CITY OF ALBUQUERQUE
PLANNING DEPARTMENT
May 9, 2007
DRB Comments

PROJECT # 1005537 APPLICATION # 07-00554

RE: NE1/4, NW1/4, Sec 8,T11N, R2E TBK Ventana Oeste/sketch

SKETCH PLAT
VENTANA OESTE

Zone Atlas Page:

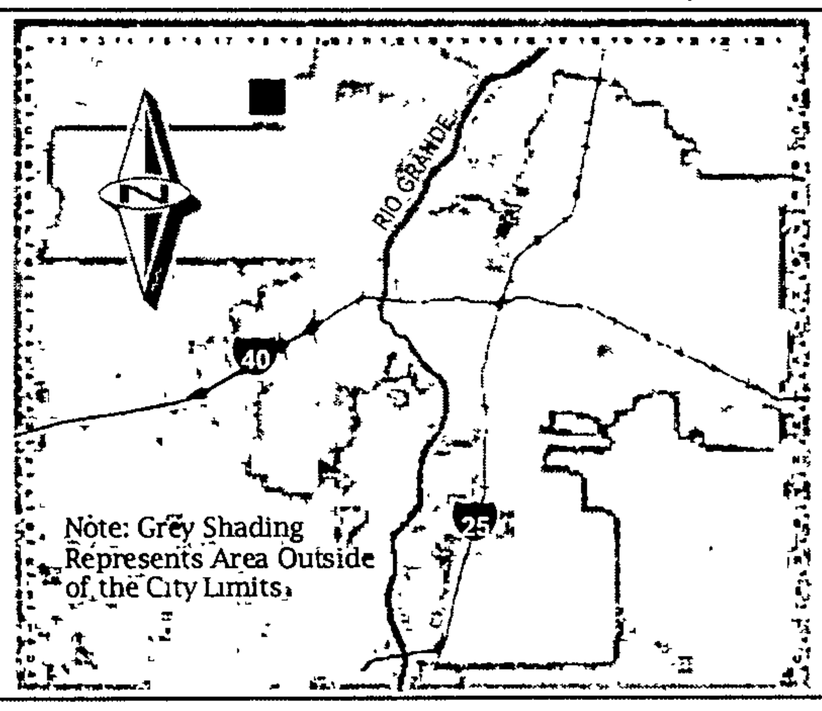
Please locate on the zoning map.

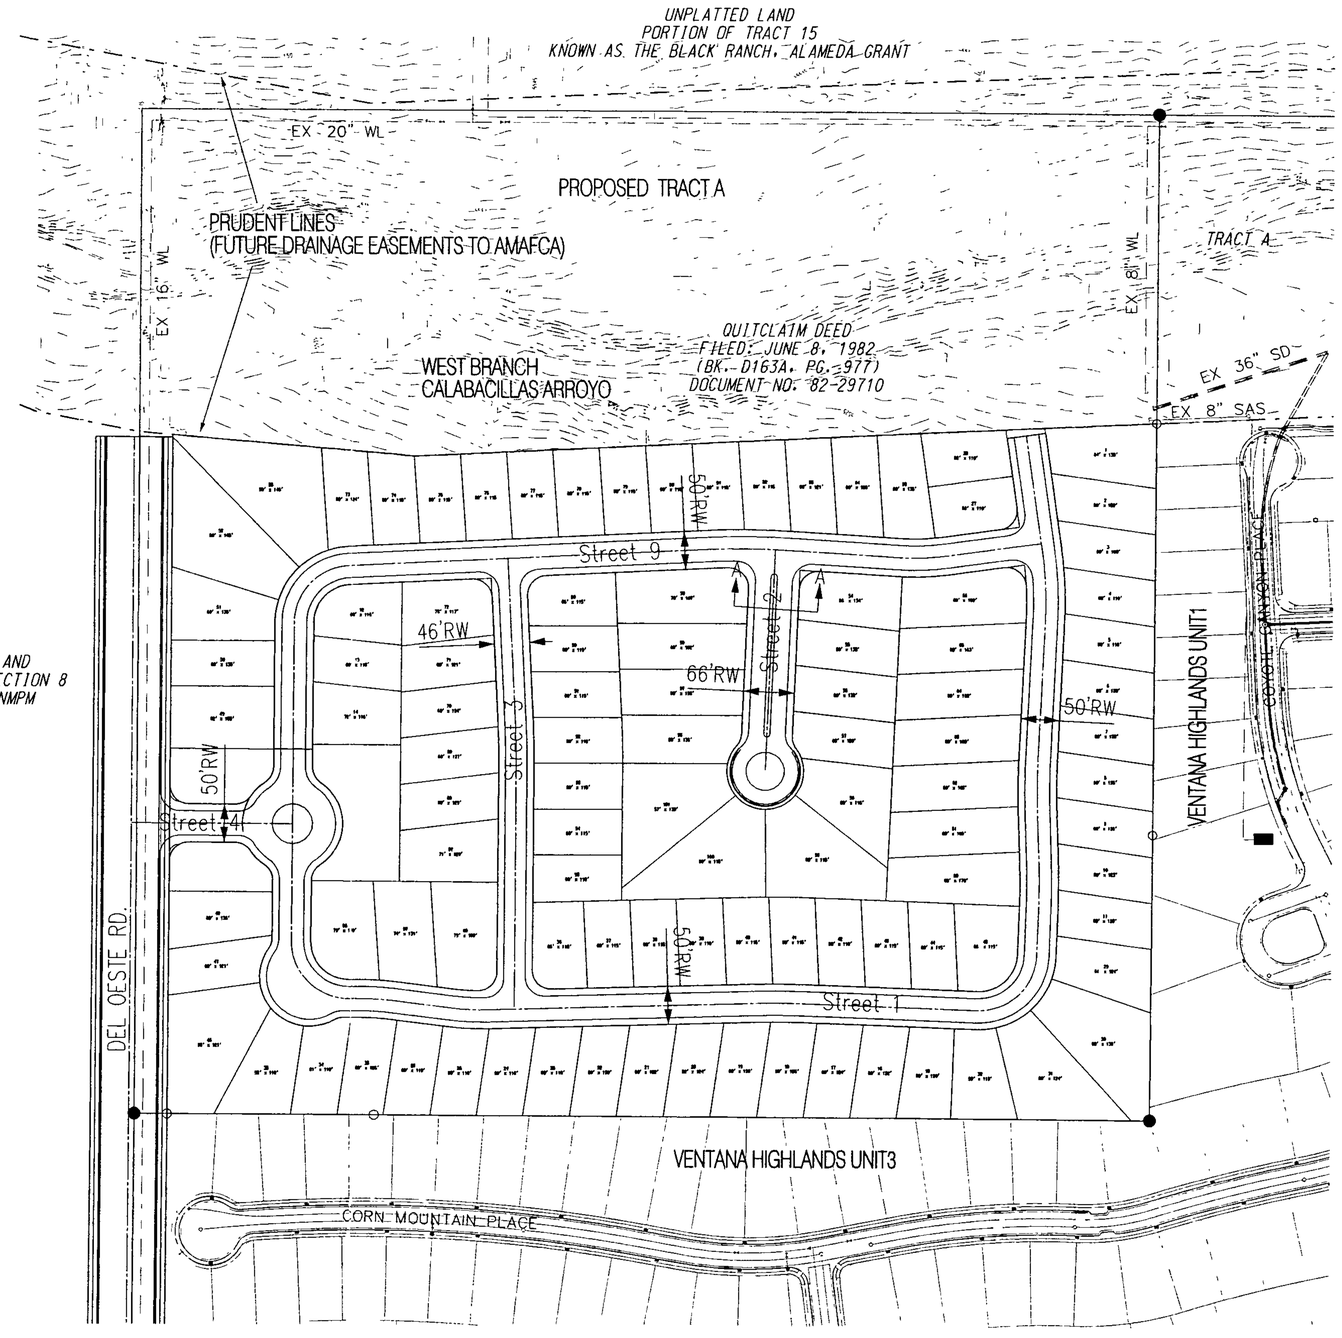
No.	Comment
1)	The subdivision does not meet the single access criteria.
2)	A traffic distribution map is need to evaluate major local criteria.
3)	Cross sections need to meet DPM criteria. (Unsure where the 46′ & 50′ sections are coming from?)
4)	How is the access along Del Oeste going to be constructed?
5)	Why isn't there dedication along Del Oeste? (County Coordination?)
6)	Standard infrastructure per the DPM is required.

An approved drainage report must be on file prior to Preliminary Plat approval.
An approved infrastructure list is required for Preliminary Plat approval.
